HORSHAM DISTRICT COUNCIL CONSULTATION

| LOCATION: | Land To The North and South of Mercer Road Warnham West Sussex |
| DESCRIPTION: | Redevelopment of the site to provide 304 residential units, parking, a retail unit, public car park, public open space, attenuation basins and landscaping |
| REFERENCE: | DC/25/0151 |

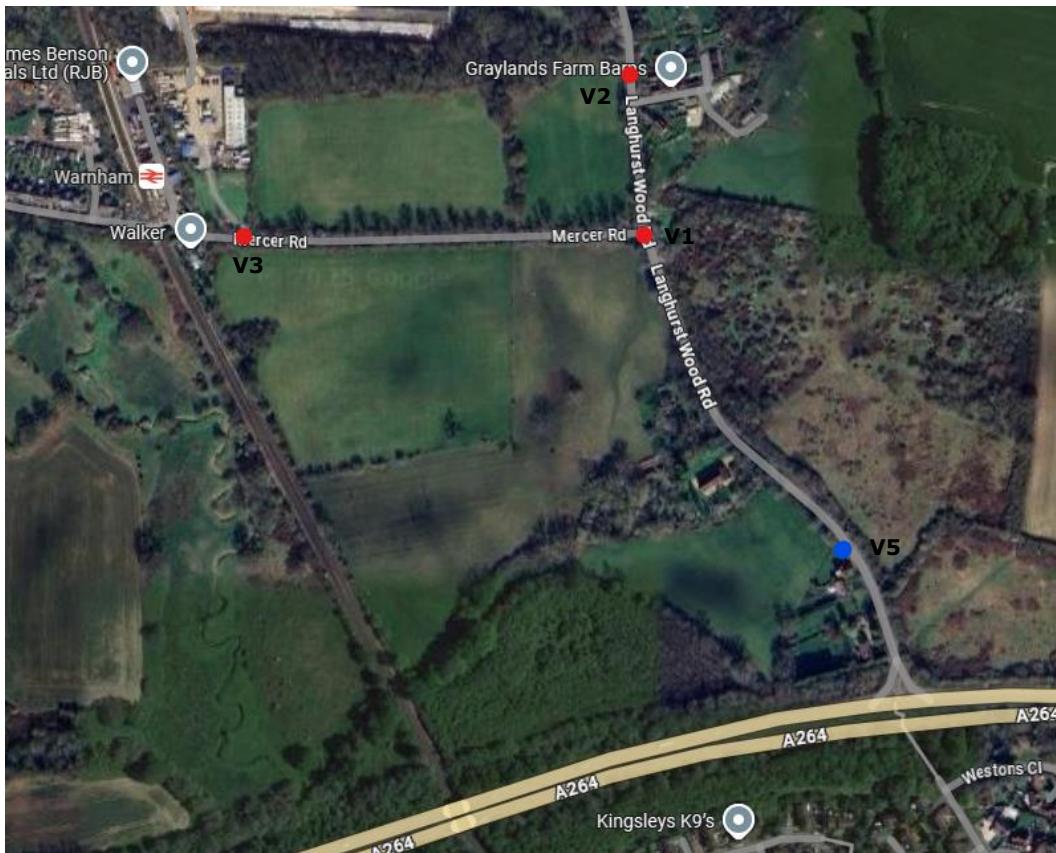
The methodology is not clear on how the various judgements interlink and key steps of the assessment, such as susceptibility to inform sensitivity, appears to be missing.

Susceptibility is a measure of the landscape vulnerability to the type of development proposed, without undue consequences of the maintenance of the baseline situation and/or the achievement of the landscape planning policies and strategies. In this case, important aspects of the landscape baseline, including the presence of important landscape features such as those found in the veteran trees, are not acknowledged. Therefore, it is not surprising that the assessment understates the likely adverse effects arising from the proposals.

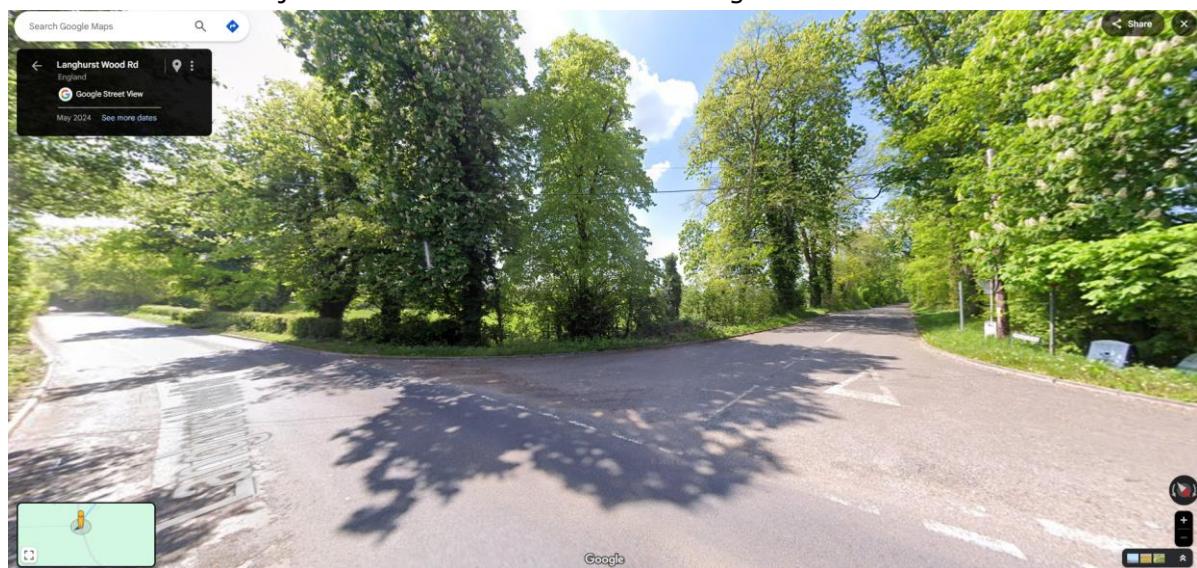
- Additional viewpoints are required as follows:

- V1: At the junction of Mercer's road and Langhurst Wood Road

- V2: Looking south towards the northern part of the development from Langhurst Wood Road

- V3: Looking east from Mercer's road and PRoW 1574

- V5: Adjusted to show more of the site as per the screenshot below. Please note that Type 3 visualisations are required for this viewpoint to illustrate the level of change.

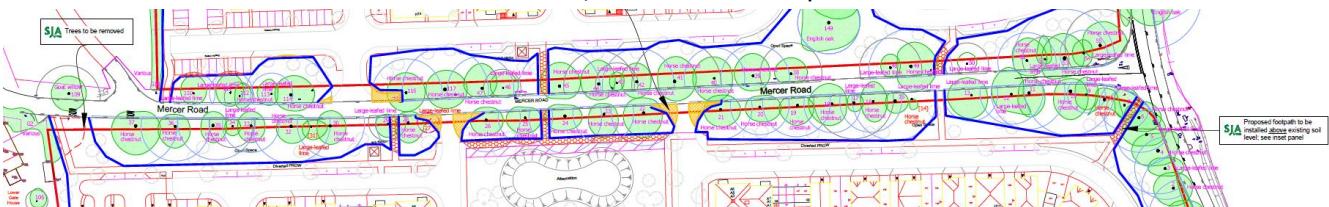
Given the undeveloped nature of the site, it is required that RPAs are entirely avoided in order to secure the retention of key landscape features such as trees and hedgerows in line with aspirations stated within the DAS, particularly along Mercer Road and the 'southern woodlands' area. The layout therefore must be amended to demonstrate no encroachment with the RPAs of B category Notable T87 with high landscape value, C category T89 of moderate landscape value, B category T103 of high landscape value, C category T69, B category T96, B category T110, B category T111 and G4 woodland. We highlight in particular possible changes to the road layout to minimise loss of mature trees and vegetation. For example:

- i. The eastern access road to the northern parcel could be shifted further south in order not to encroach the RPA of T96.

- ii. We recommend relocating the associated pump house to be within the triangular parcel adjacent to the housing, in order to minimise earthworks and utilities in proximity to the woodland, providing space for a more substantial vegetated buffer.

- iii. 2no. vehicle access routes are proposed along the south of Mercer Road, as well as an additional 5no. pedestrian access routes, resulting in tree and vegetation loss as well as RPA encroachment. We recommend that this is reduced to 1no. vehicle access route and a maximum of 2-3no. pedestrian access routes in order to prevent unnecessary vegetation loss and indirect adverse effects to mature vegetation which may result in vegetation deterioration and loss, at odds with aspirations stated within the DAS.

- iv. The pump station in the south-west should be relocated, as above, in order to retain the mature, established boundary vegetation.
